**From:** [Joel Geier](#)  
**To:** [Coffin Butte Landfill Appeals](#)  
**Subject:** LU-24-027: Risk of impacts on water availability from wells and springs  
**Date:** Monday, October 20, 2025 1:39:43 PM  
**Attachments:** [Well impacts Joel Geier 2025-10-20.pdf](#)

In this note, I will give you yet another reason to uphold the careful and thoroughly considered decision of your Planning Commission, to deny this permit application, specifically: **Risk of impacts on water availability from existing household and farm irrigation wells**

## Risk of impacts on water availability from existing household and farm irrigation wells

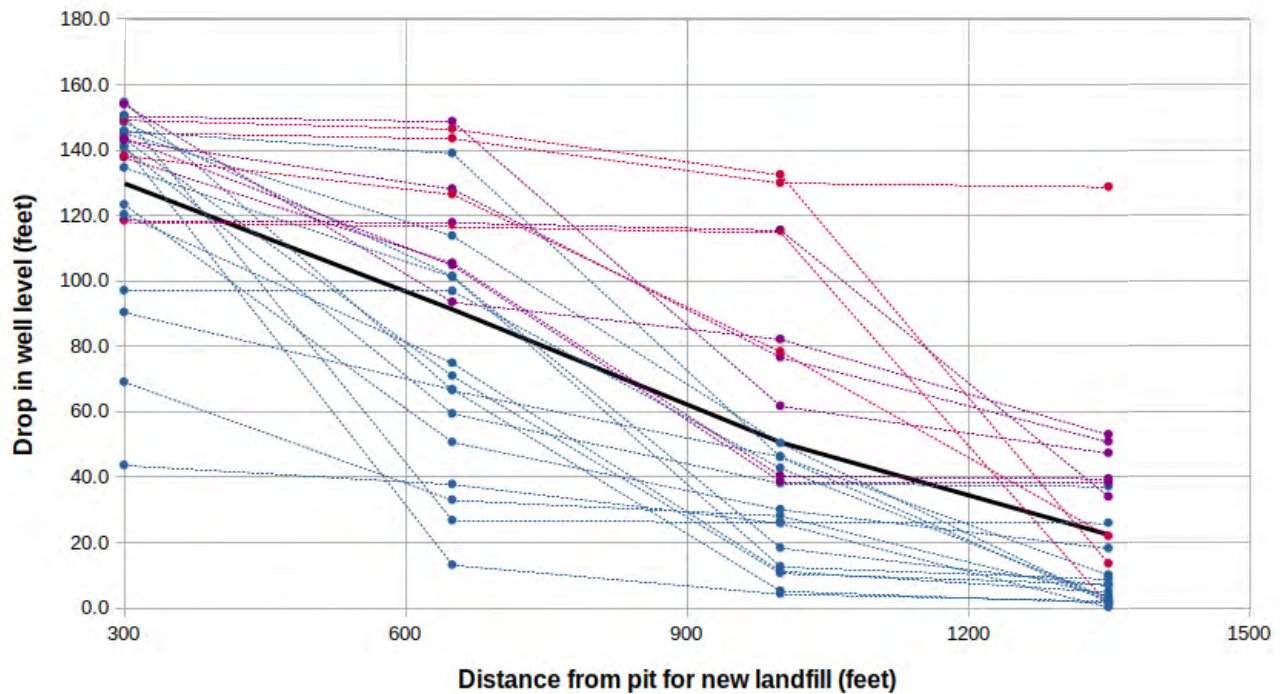
One way to check if a model is conservative is to compare with predictions of an alternative model of the same system. **Figure 1** gives the results of calculations with a very simple model of the type of groundwater flow system that can be

expected for domestic and farm wells on Tampico Ridge. The model follows an approach that has been applied in support of regulatory decisions by Swedish government agencies, for licensing of both high-level and low/intermediate-level radioactive waste disposal facilities. A paper prescribing the method and practical applications has undergone scientific peer review and was published in the official journal of the International Association of Hydrogeologists.<sup>12</sup> The assumptions of the model are stated below.

This model predicts that, on average, **wells or springs at a distance of 1000 ft (333 yards) will see a drop of over 50 ft**, and at a distance of 1350 ft (450 yards), a drop of over 20 ft. In 28% of the realizations, **drops of over 70 ft** are predicted.

The flow system considered by this model is a simple series (chain) of fractured zones, each of which behaves as a confined aquifer connecting between its ends. For the sake of simplicity, each fractured zone is assumed to be 5 feet thick (a typical thickness for water-bearing zones in local wells), and extends for 300 ft from end to end. The hydraulic conductivity of each zone is drawn from a lognormal distribution with median value of 2.7 ft/day (the geometric mean value cited by the applicant's Exhibit 68), with a standard deviation of 1.5 orders of magnitude (a typical range of variation for fractured bedrock).

As with any model, the detailed assumptions of this particular model could be discussed. However, the main purpose here is just to demonstrate that the model presented by the applicant is not conservative for the purpose of application.
